| Cow Tag 178 | | Function Code P8-3 |
| Brief Description: [timber element, p/s, condition, fragments] <i>Complete plank. Split damage at aft scarf</i> | | |

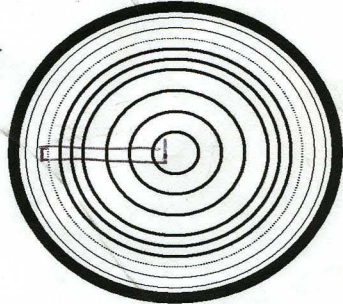
| Notable Features: [tool marks, scribed lines, decoration, repairs] POINTS TO LOOK OUT FOR WHEN RECORDING ufos <i>Has repair along lower edge</i> <i>Type 1 Inscribed line?</i> <i>Old control points recorded and removed.</i> <i>Need to add wood fastener centres layer</i> | | |
| Recommended action: [samples, additional photos, moulding, queries and problems] <i>Plus repair</i> | | |

change layer
- add new?

needs clearing out

need to
define step in scarf
